re: **ALEXANDER, 9 HUMFFREY STREET, GROVETOWN**

Discharge Permit Application, L.A Alexander – Grovetown

**MARLBOROUGH DISTRICT COUNCIL
WASTEWATER MANAGEMENT UPGRADE
LOT 1 D.P. 2743
9 HUMFFREY STREET, GROVETOWN**

MDC-ALEXANDER
9 HUMFFREY ST
GROVETOWN

site plan- AWTS & drip

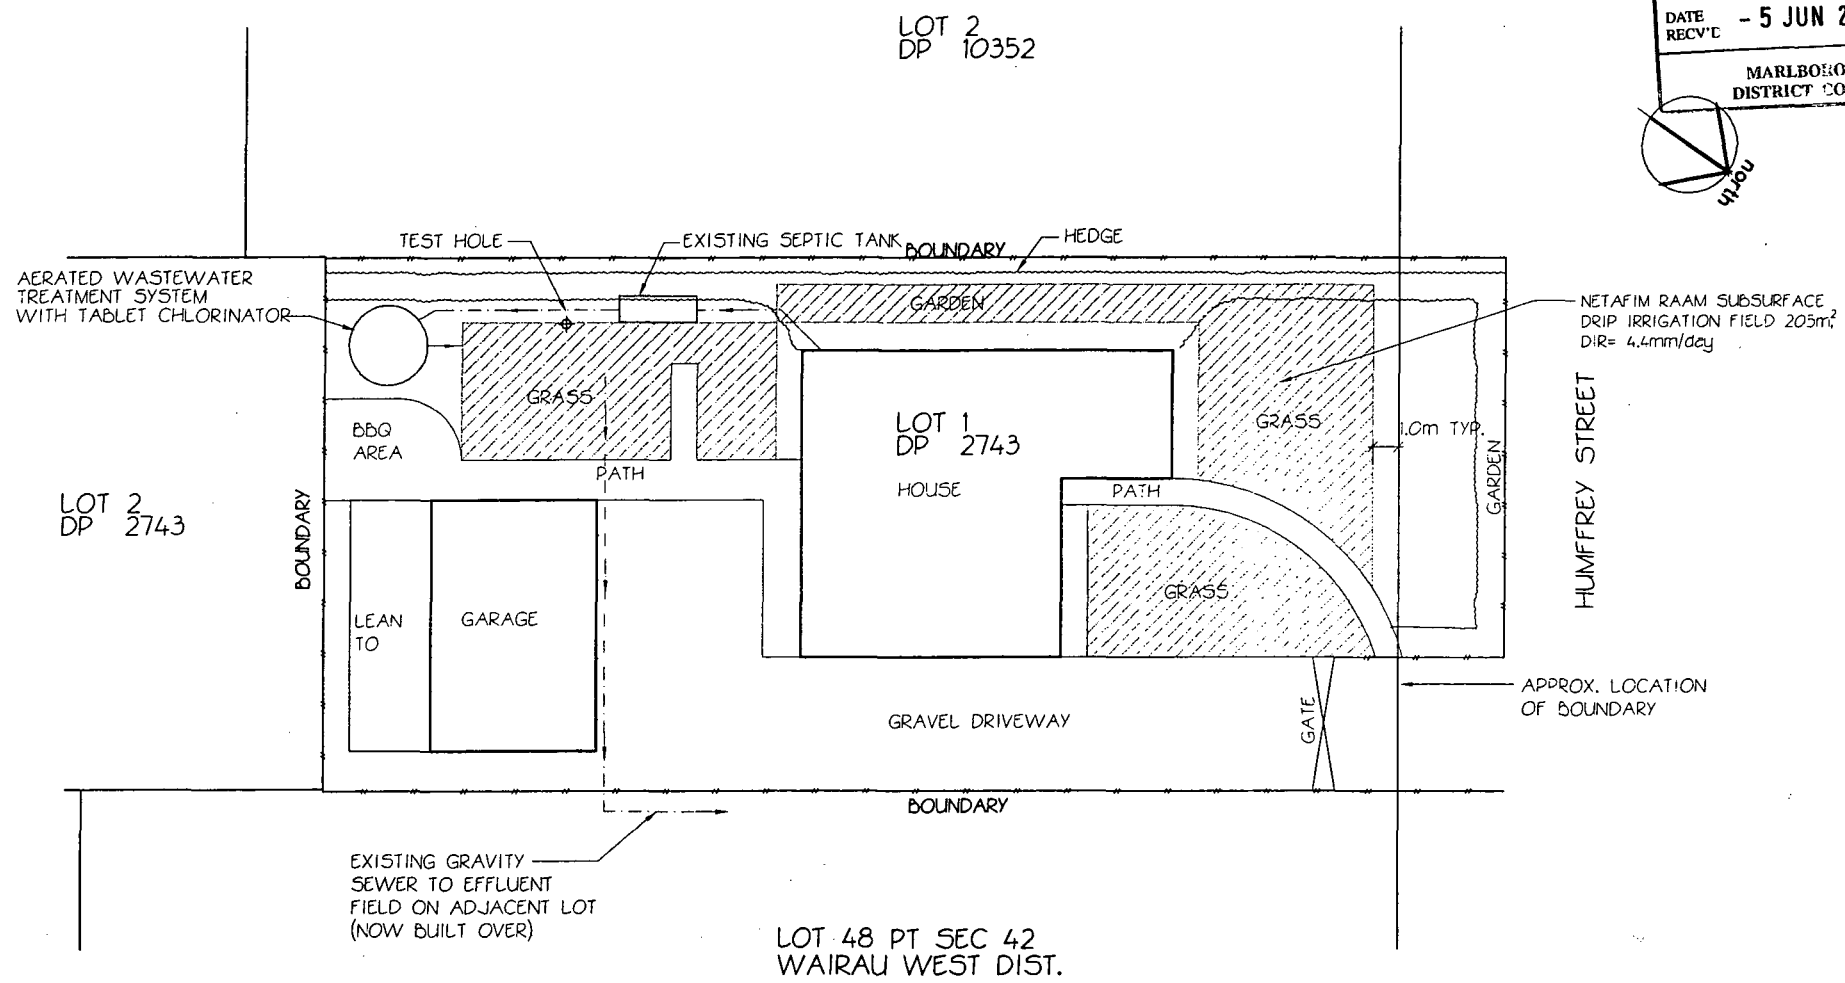
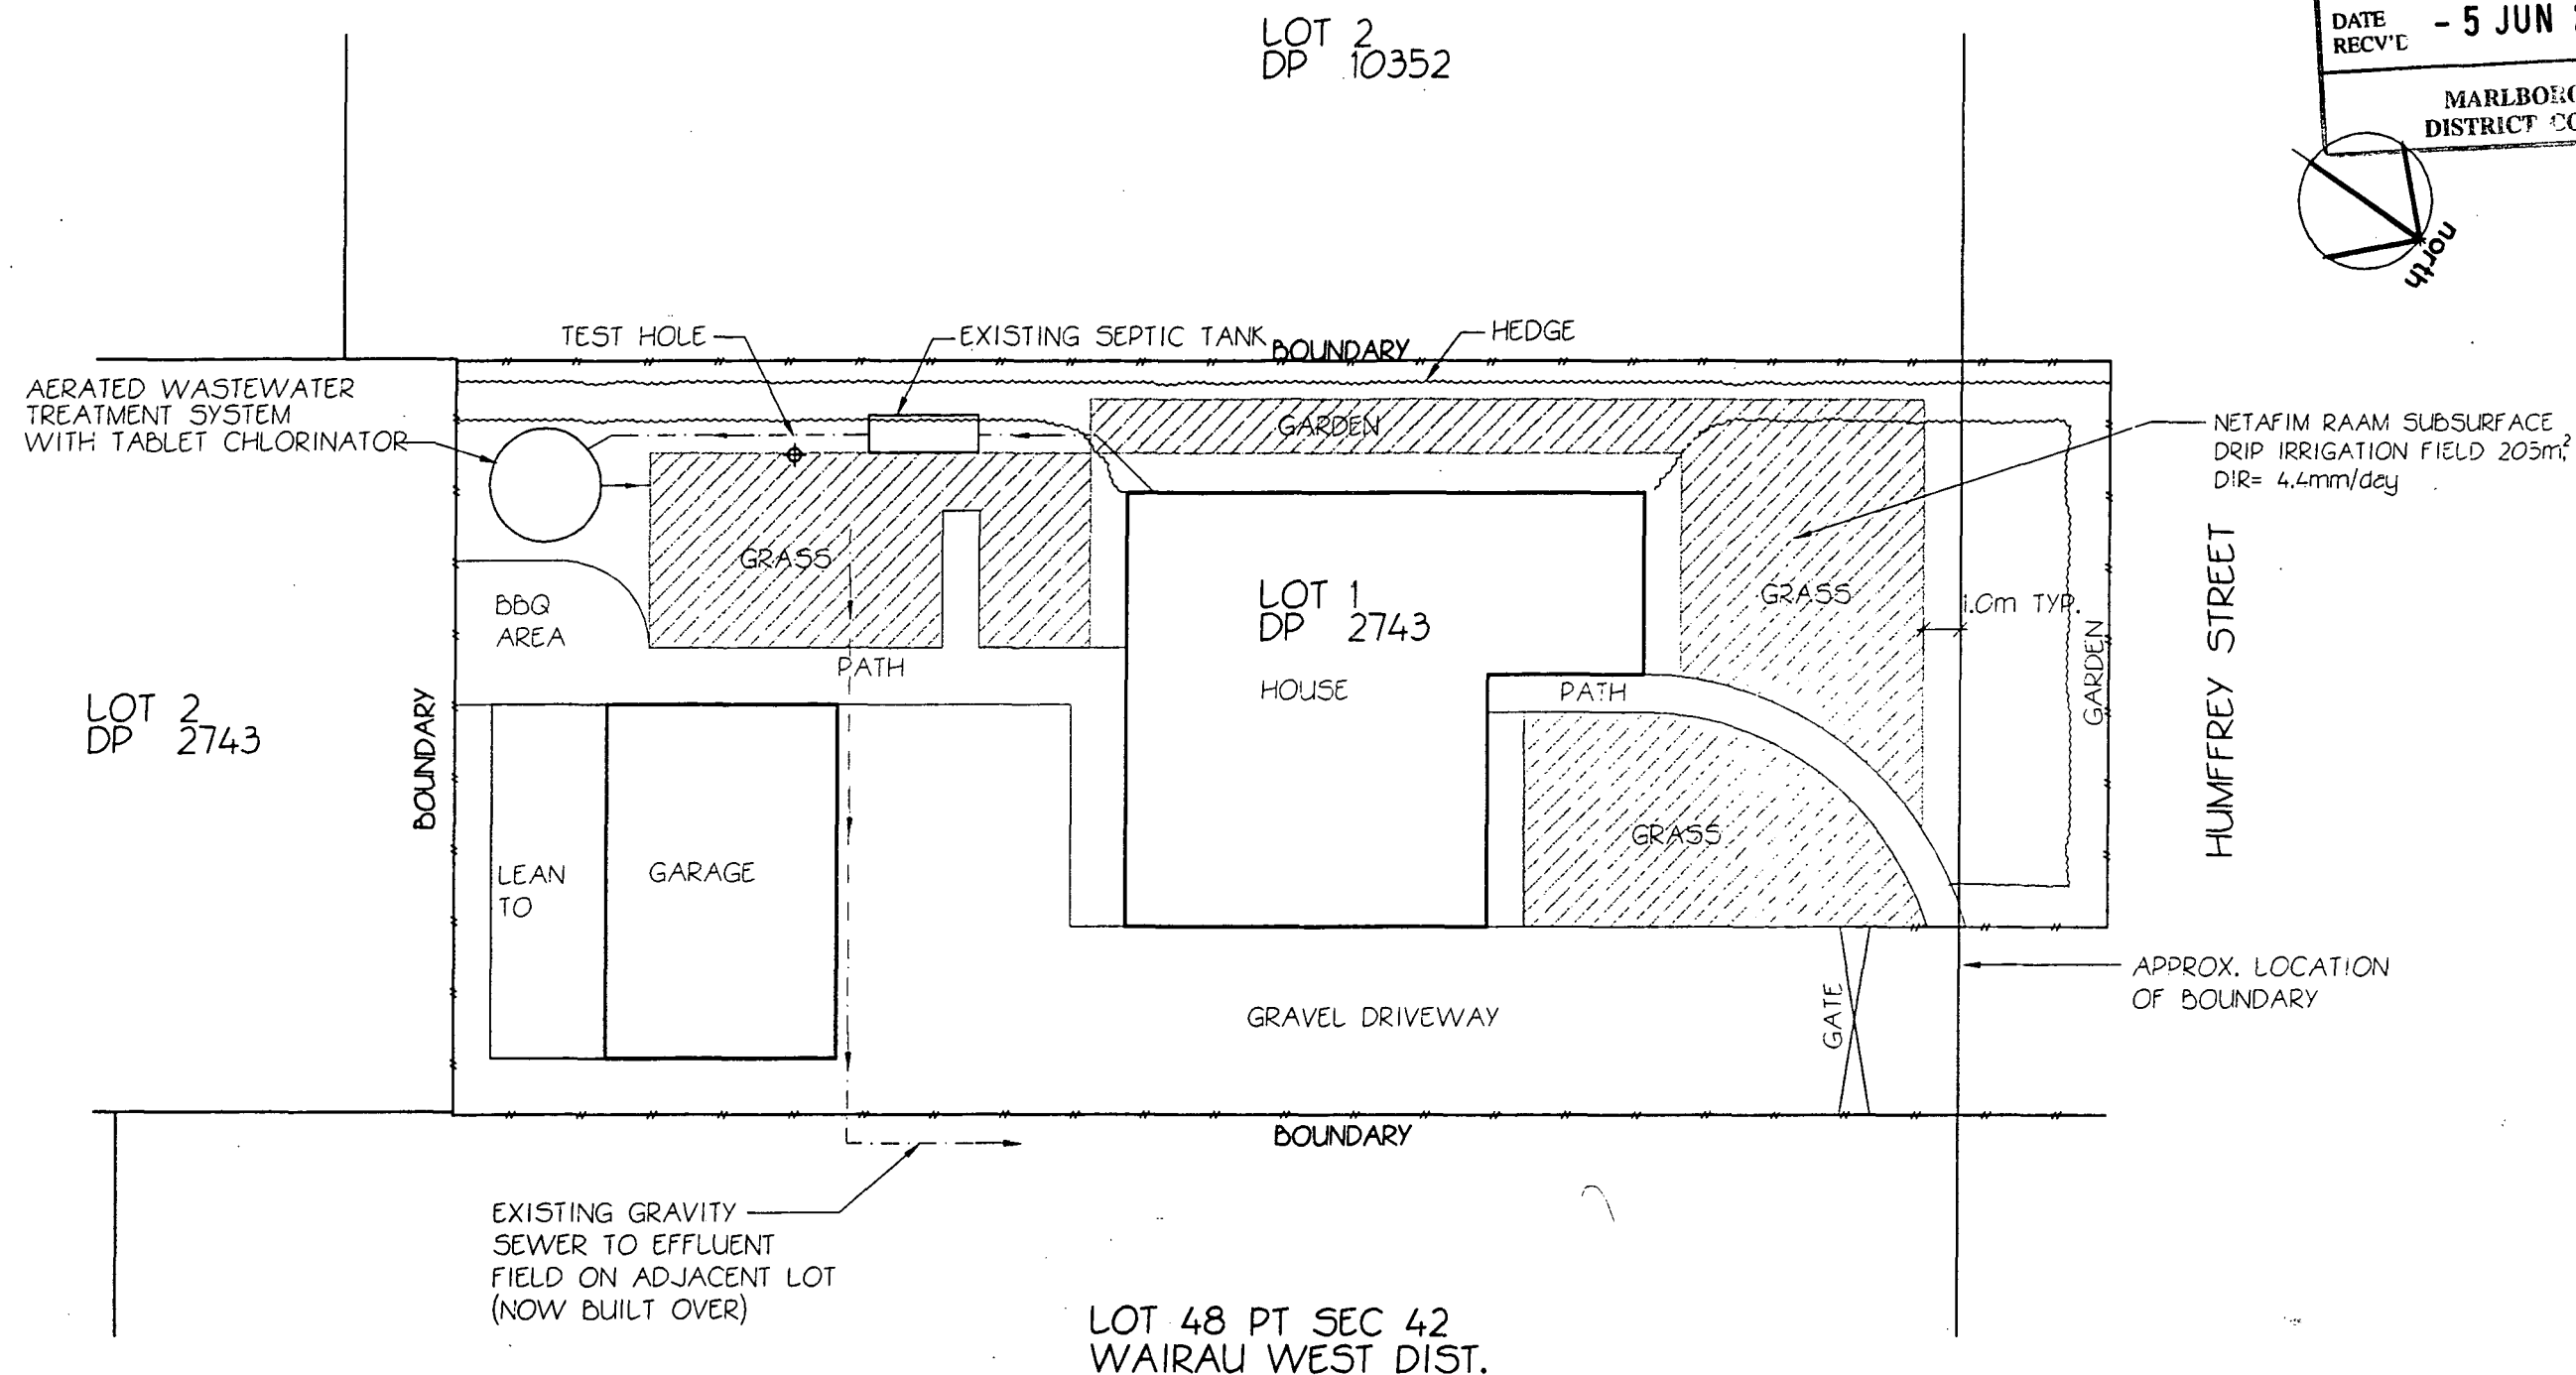
- Faecal Coliforms
 - Total Suspended Solids
 - BOD
4. Could you please provide assessment of environmental effects particularly on groundwater. This assessment should recognise the depth of the groundwater, the nature of the effluent and the rate at which it is to be discharged. Your report specifies that an acceptable DIR for the site is 3.0mm, but the plans show a DIR of 4.4mm. Could you please provide further comment.

In regard to loading rates, we evaluated two options. We considered a loading rate of around 3.0 mm per day to be suitable, which could be achieved with the use of the area of Road Reserve which is in garden. It is usual to contain land application areas within the subject property, which restricted the available area to 205 m² and raised the loading rate to 4.4 mm per day. We would only be happy with this if additional treatment of the wastewater was provided, hence the specification that if an increased loading rate was to be used then disinfection is required.
